REGULAR MEETING OF THE PLANNING COMMISSION

April 17, 2024 at 7:30 p.m.

- 7. PUBLIC HEARING: DESIGN REVIEW APPEAL – 1711-1755 EASTSHORE BLVD.**
Application: PL24-0013
Applicant: Contra Costa Residents for Responsible Development
Location: 1711-1755 Eastshore Boulevard
APN: 513-371-001, 513-371-002, & 513-362-110
Zoning: Transit-Oriented Higher-Intensity Mixed Use (TOHIMU)
General Plan: Transit-Oriented Higher-Intensity Mixed Use (TOHIMU)
Request: Appeal of Design Review Board approval of Tier II Design Review application PL22-0015, for a new 6-story building containing 305 residential units.

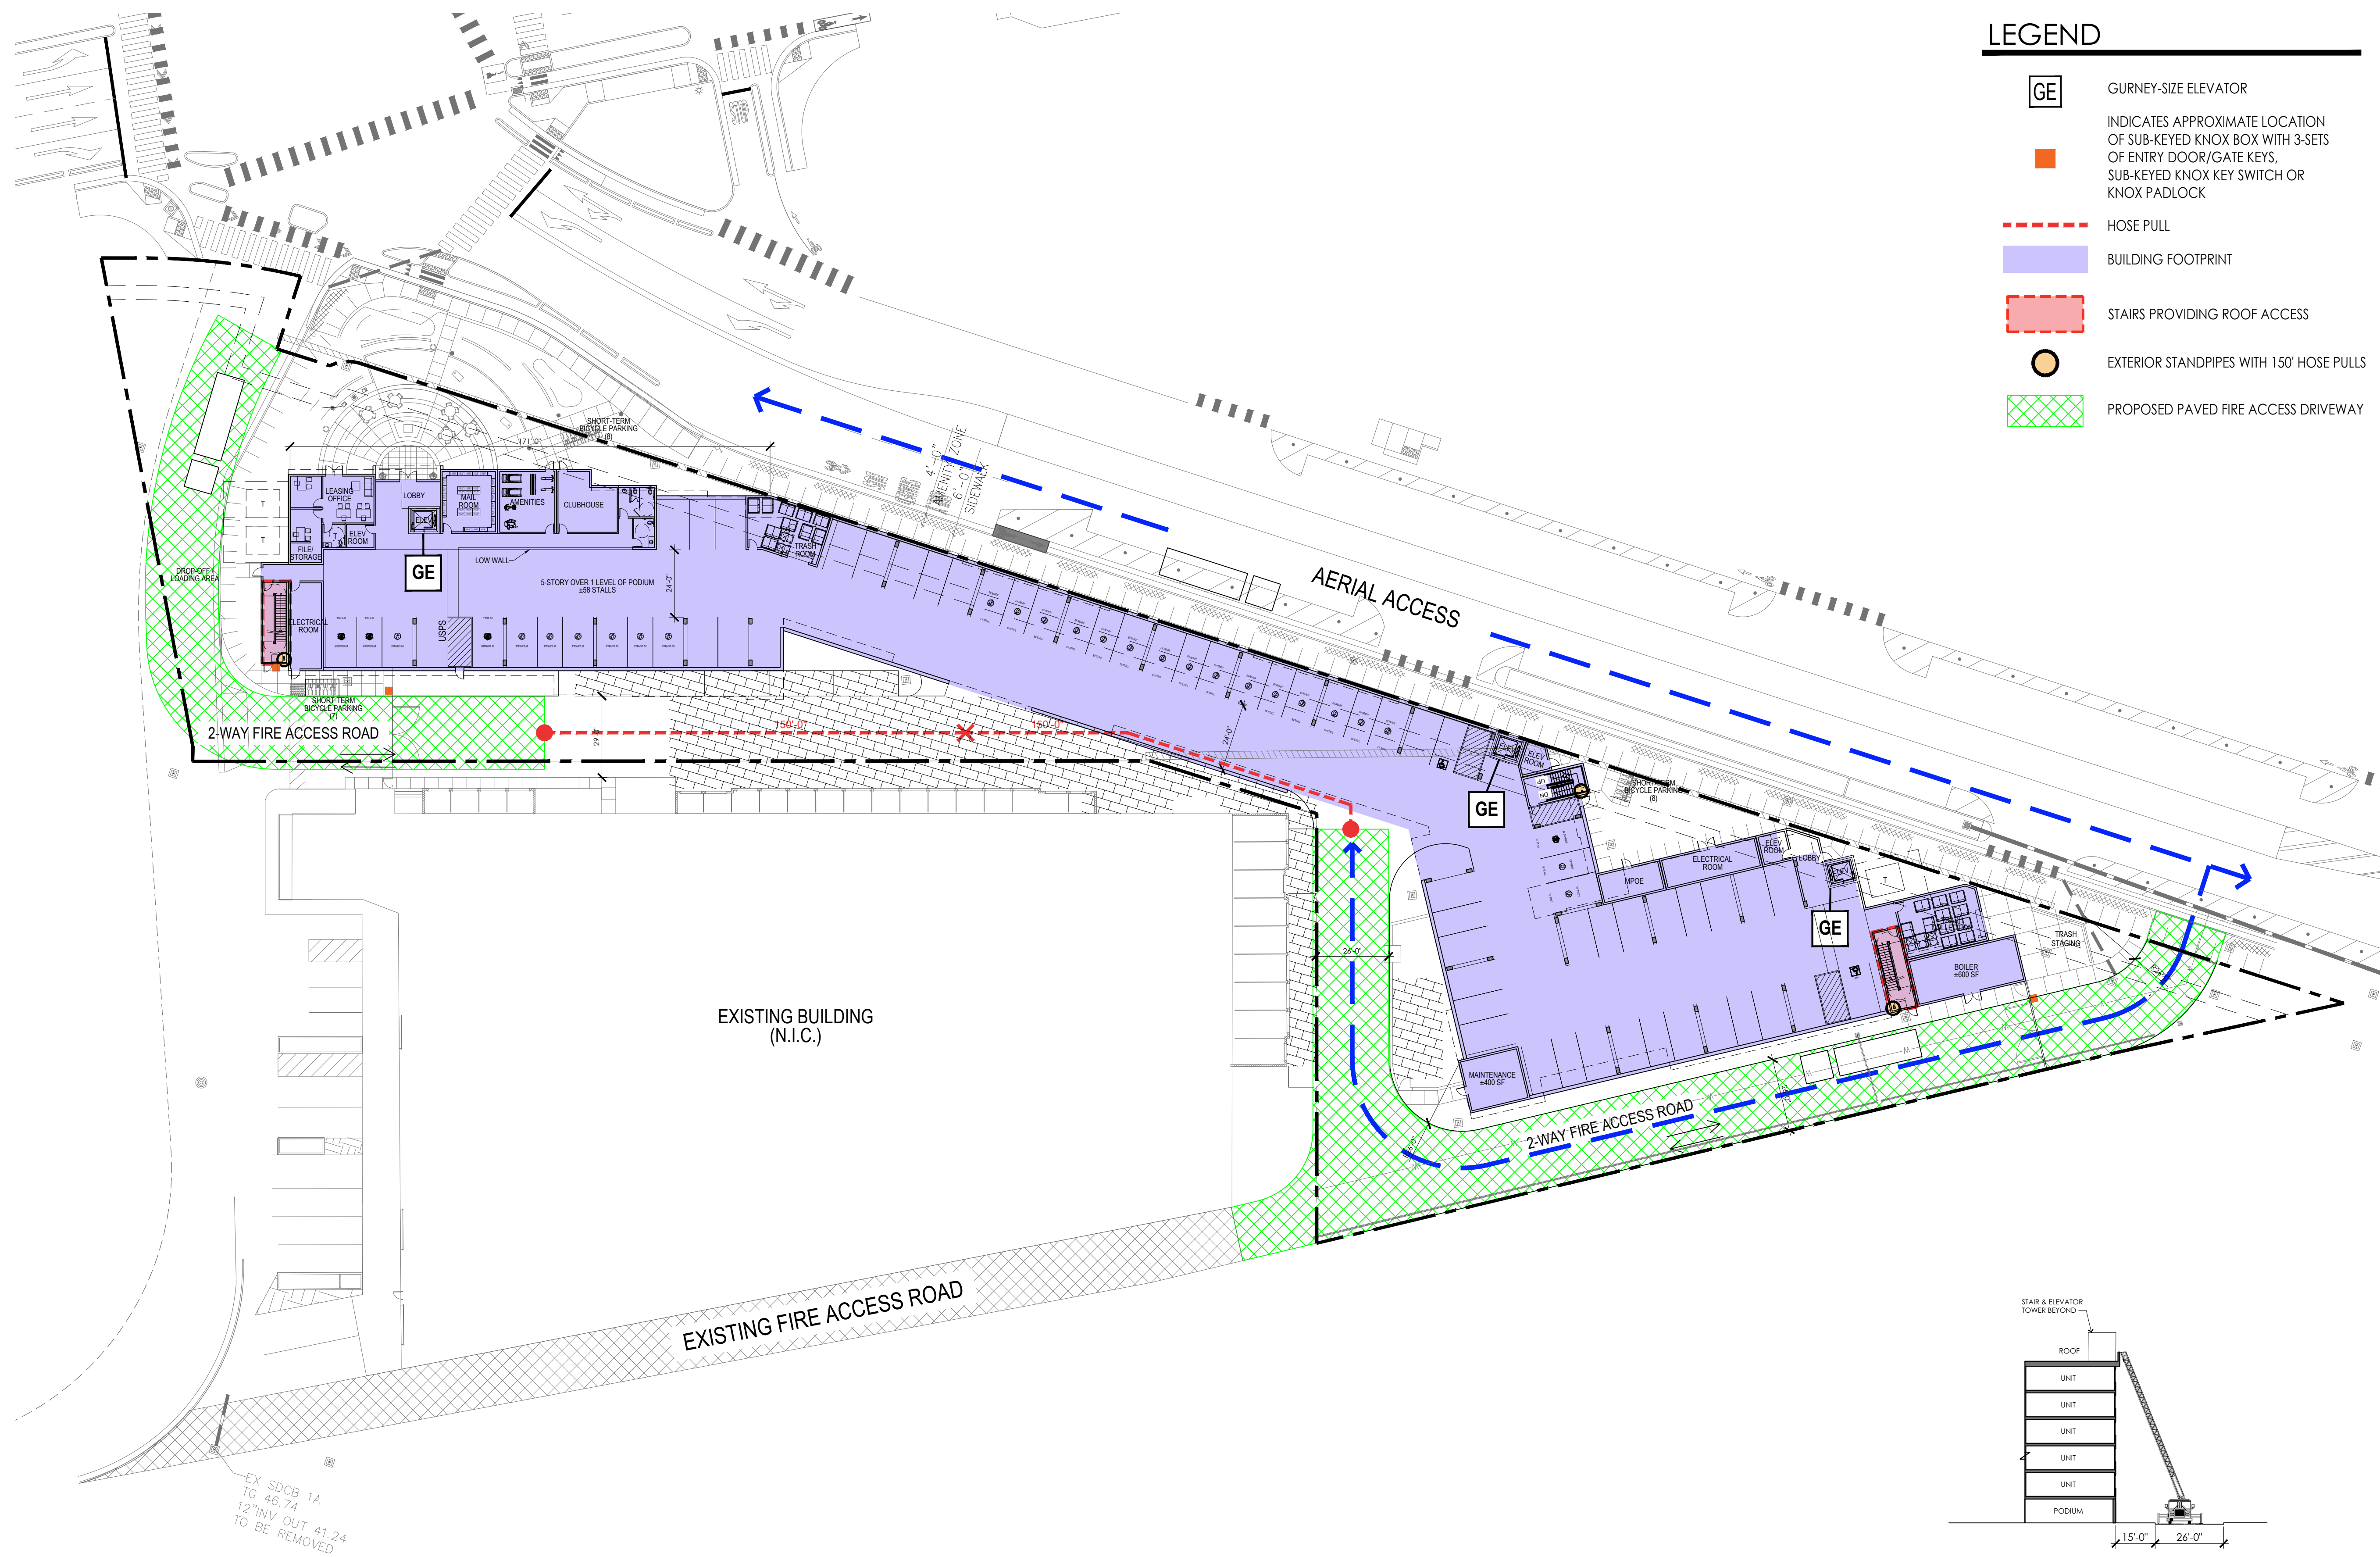
52. Sheet A2.0: The parking structure below the podium appears to be designed as an enclosed parking garage. Prior to issuance of a building permit, the plans shall be revised to provide a mechanical ventilation and exhaust system per CBC 406.6.2, or if the parking structure is open, provide openings complying with CBC 406.5.2 and document them on plans, similar to the window study on Sheet A6.2.

58. Space Allocation for Fire Pump and Generator
 - a. The Fire Department notes that the Ground Floor plan on sheet A2.0 indicates various MEP rooms. It is the responsibility of the applicant to include the necessary spaces for a Fire Pump and Generator. Note that the ECFD does not consider PG&E to be a reliable source of power in emergency conditions. Since the current plan does not indicate dedicated spaces for those components, it is the responsibility of the applicant to provide such space as required by an engineer and any associated code clearances/access.

Response: A new clubhouse area is provided on the ground floor in place of some parking stalls on the northeaster area of the building (see Sheet A2.0). In addition, a new outdoor amenity deck is proposed on the second floor on the southern tip of the building (see Sheet A3.1). Two reading rooms have also been added on each residential floor (Sheet A3.1)

Response: The size of the main lobby has been increased and a secondary lobby on the southern side of the building has been added (Sheet A2.0).

A3.1

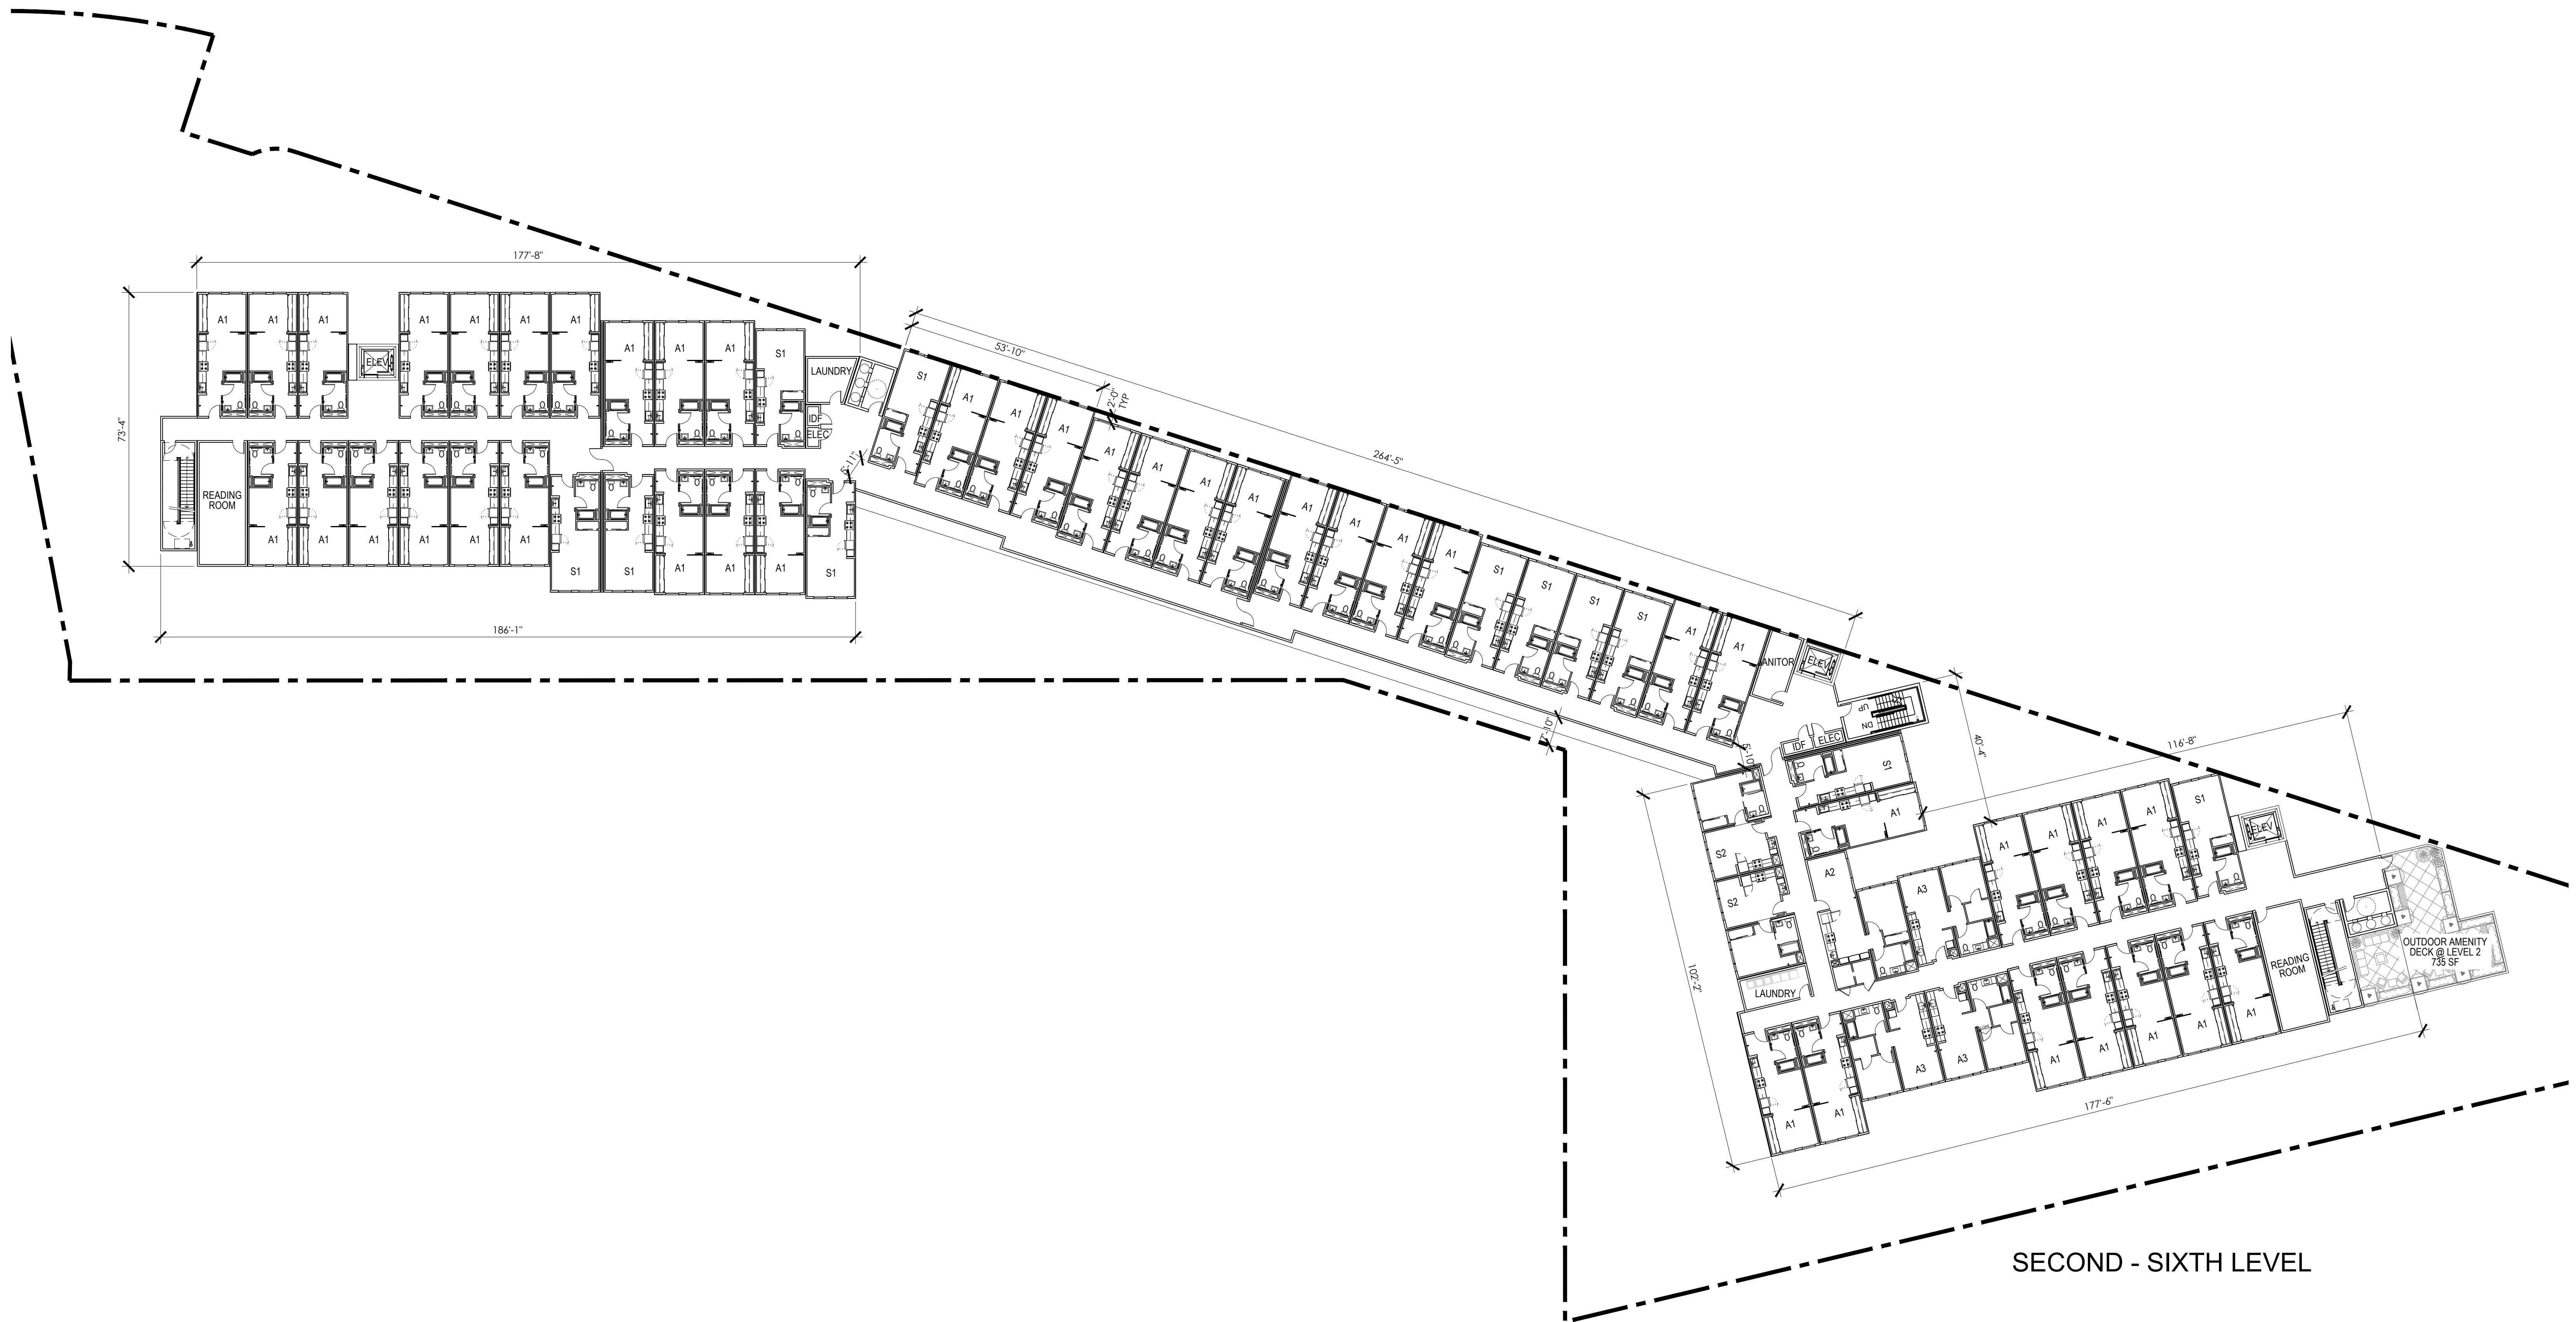
37. Prior to the issuance of a Building Permit, the applicant shall update the Stormwater Control Plan to show the roof, as depicted on sheet A3.1, and indicate all roof leaders feeding into the treatment area.

Response: The single corridor has been revised with a more inviting design, featuring a minimum 2'-0" building plane depth and new window layout. Refer to Conceptual Building Composite Plans on Sheet A3.1 and Conceptual Building Elevations on Sheets A5.1 and A5.2.

A3.2

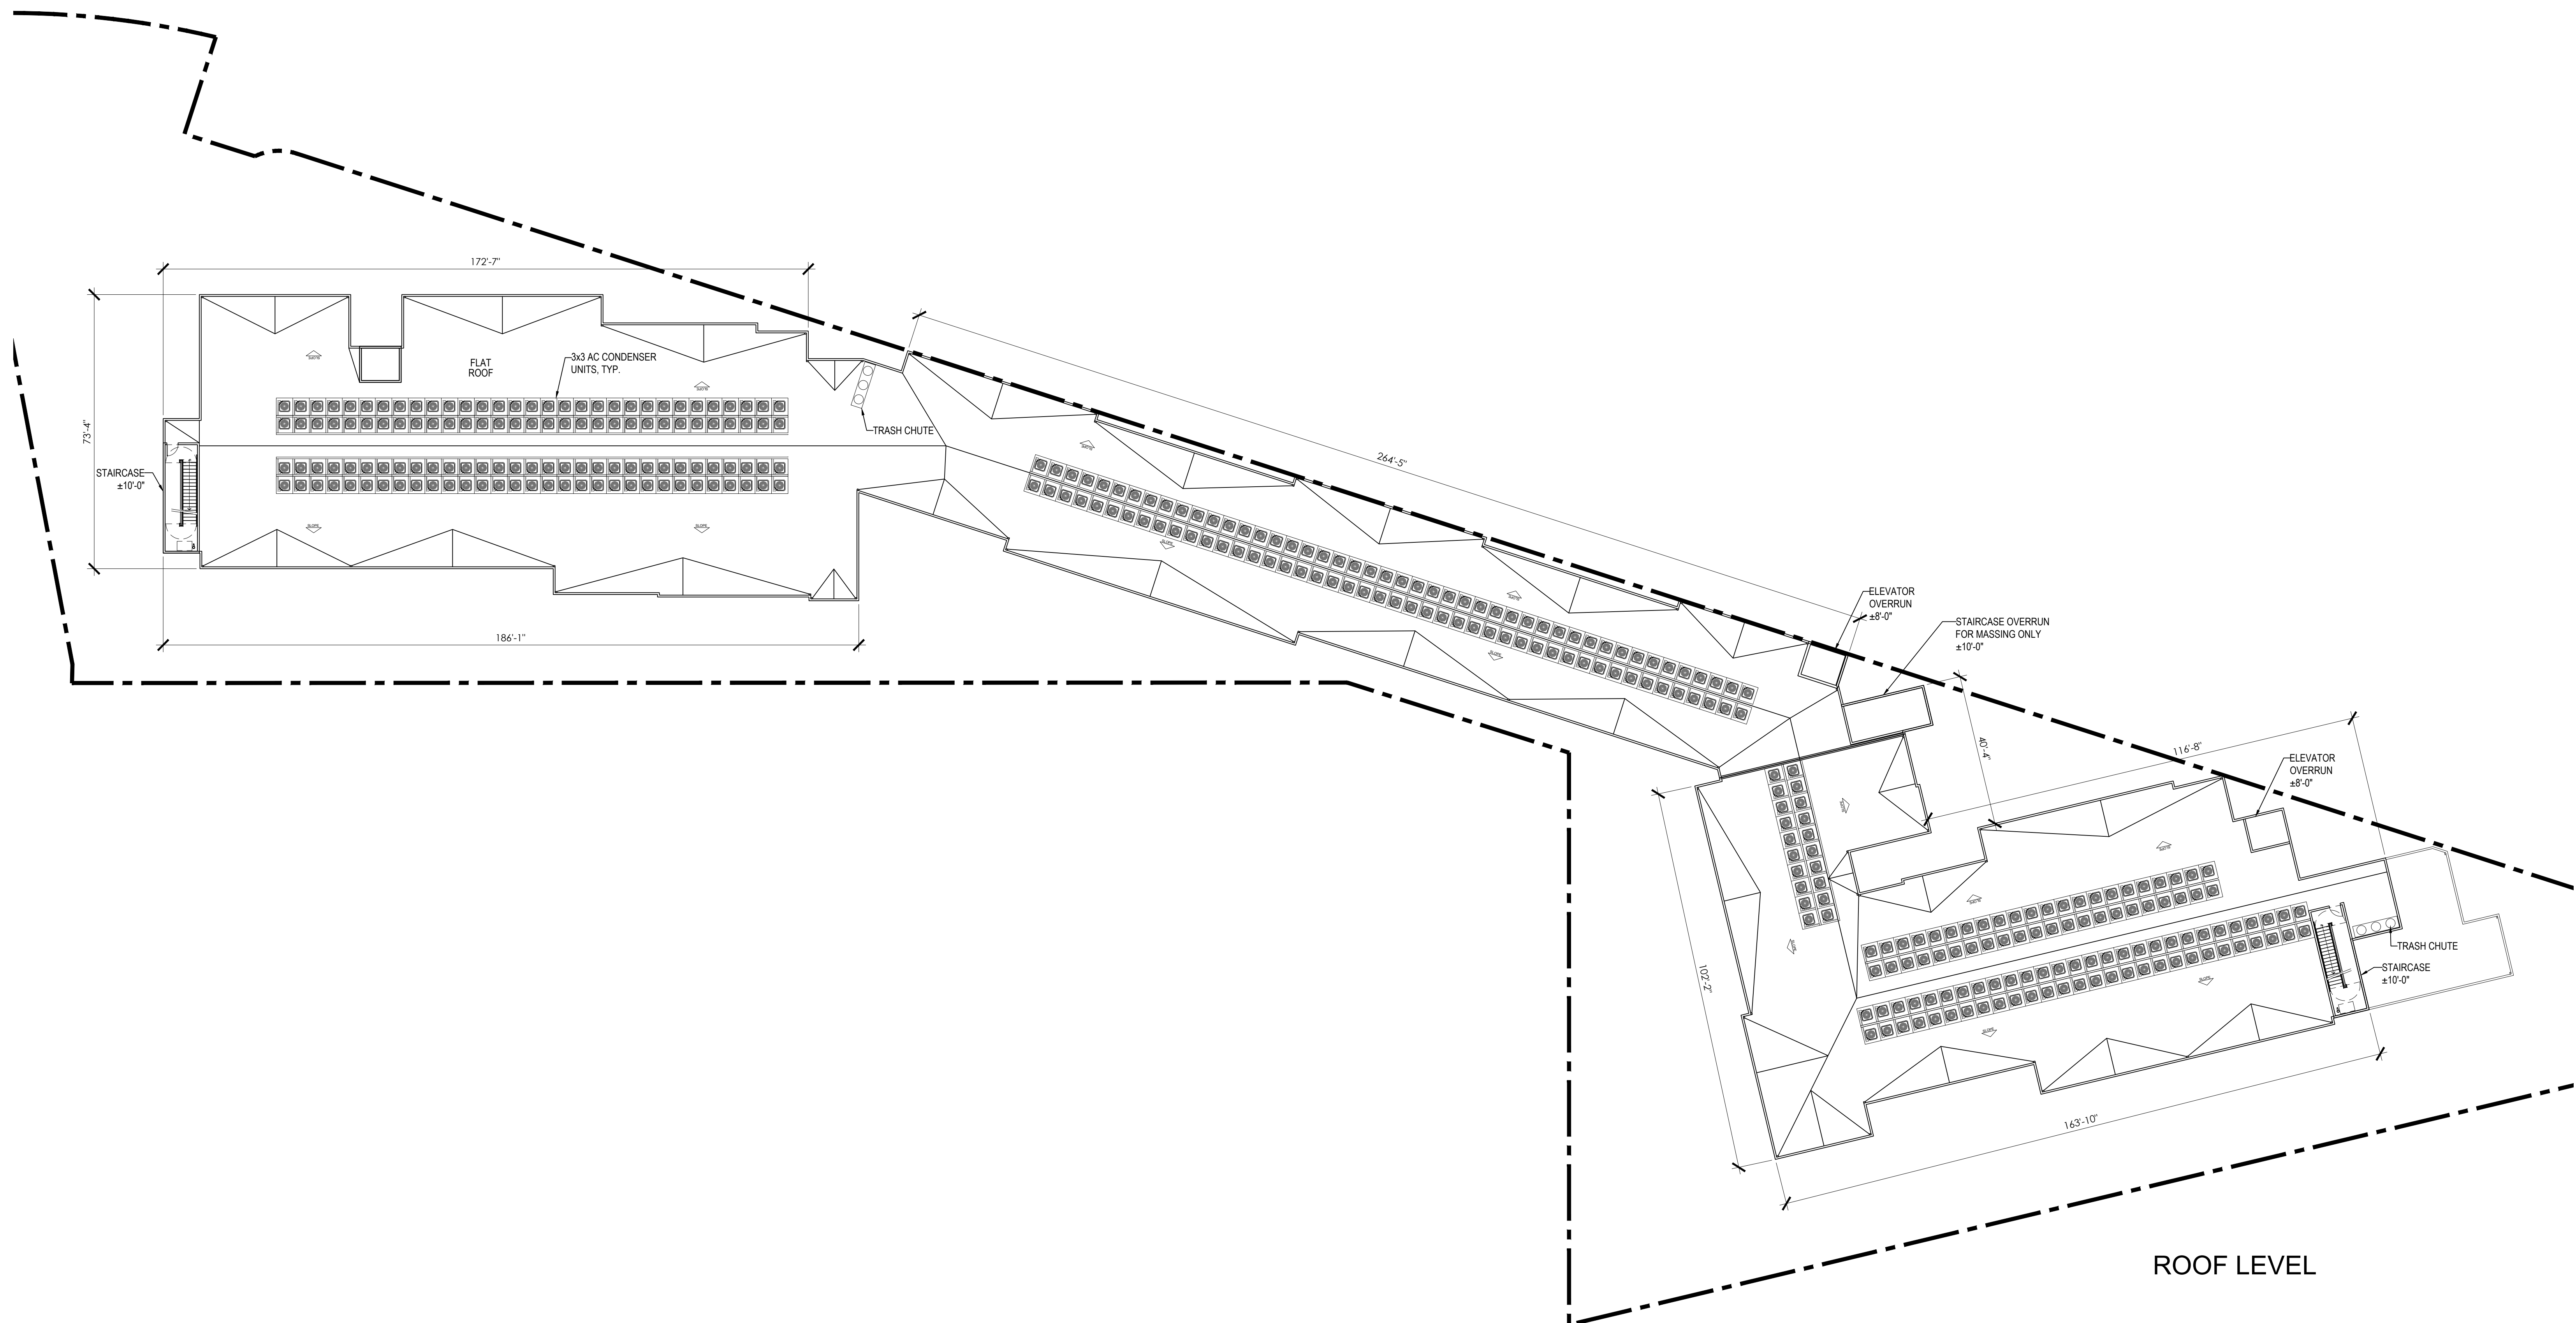
56. Sheet A3.2: All multifamily buildings under 10 stories must be solar ready per CEnC 110.10(a)3 at a minimum. Prescriptively, both a PV system and batteries are required – see Equation 170.2-D for required PV size, and equations 170.2-E and F for required battery energy and power capacities. Prior to issuance of a building permit, show the allocated PV and battery spaces on plans. [CEnC 170.2(g) and (h)]
